BRUNSWICK STEAM ELECTRIC PLANT, UNIT 1
NRC DOCKET NO. 50-325
OPERATING LICENSE NO. DPR-71
REQUEST FOR LICENSE AMENDMENT
FUEL CYCLE 11 RELOAD LICENSING

TYPED TECHNICAL SPECIFICATION PAGES - UNIT 1

FIGURE 3.1.5-1

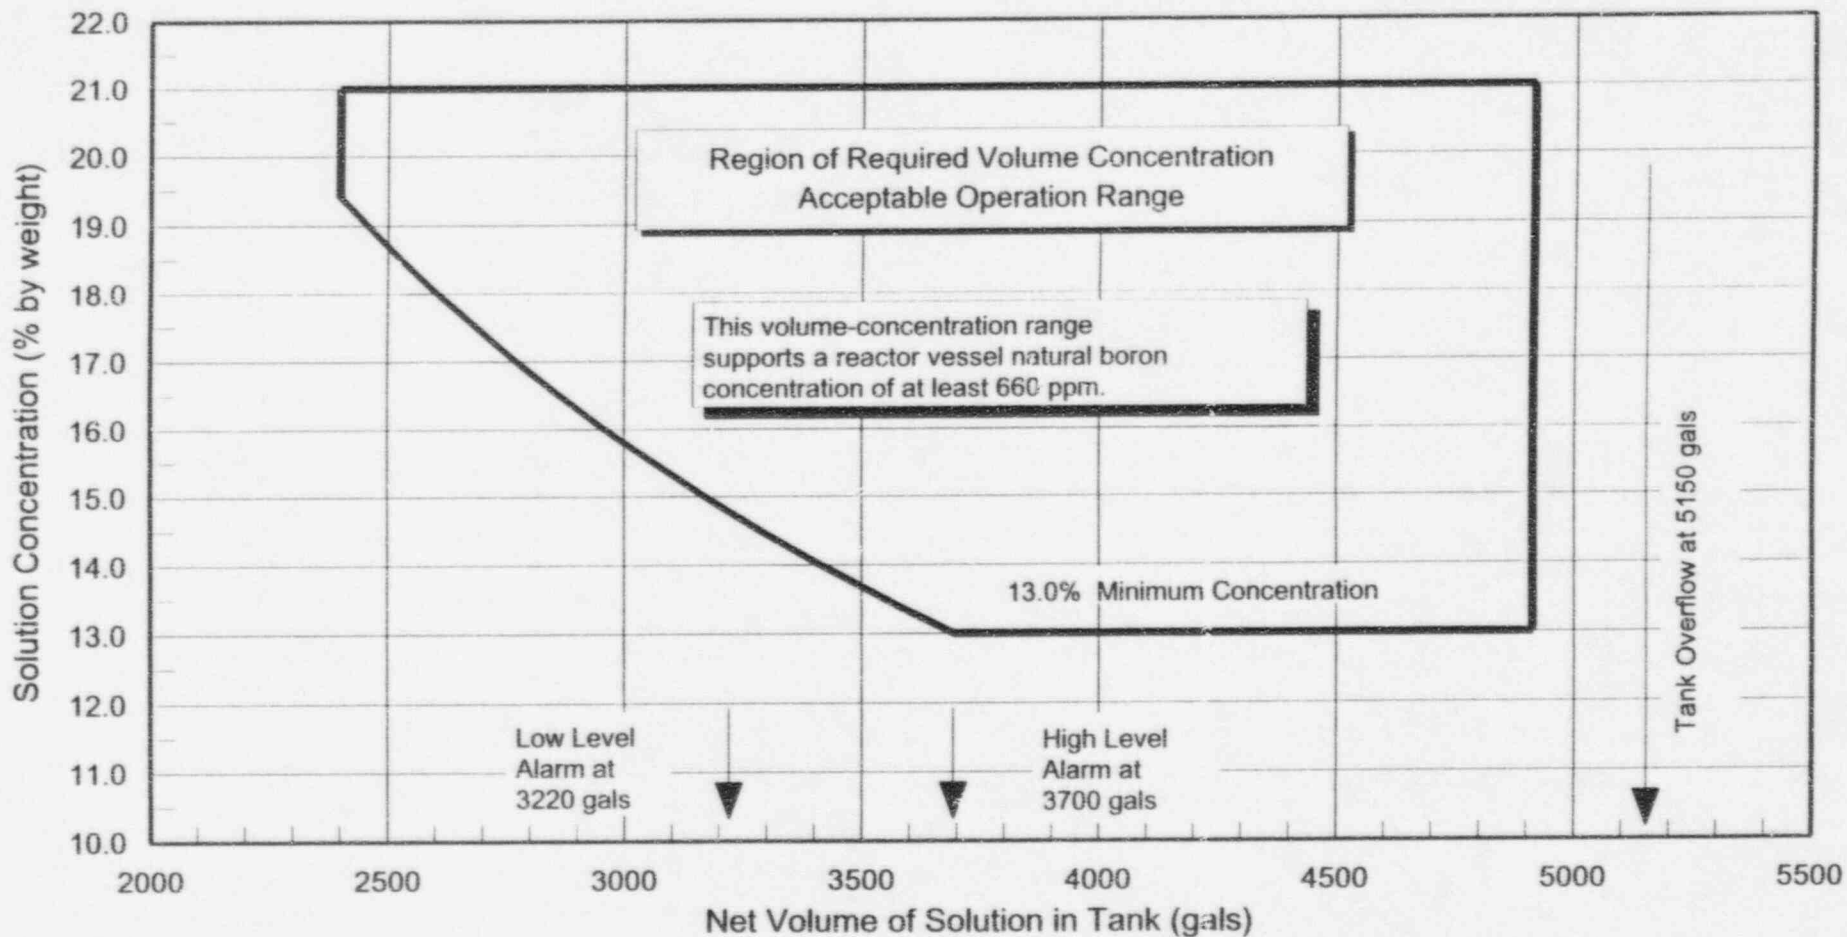
REPLACE AS SHOWN (ATTACHED)
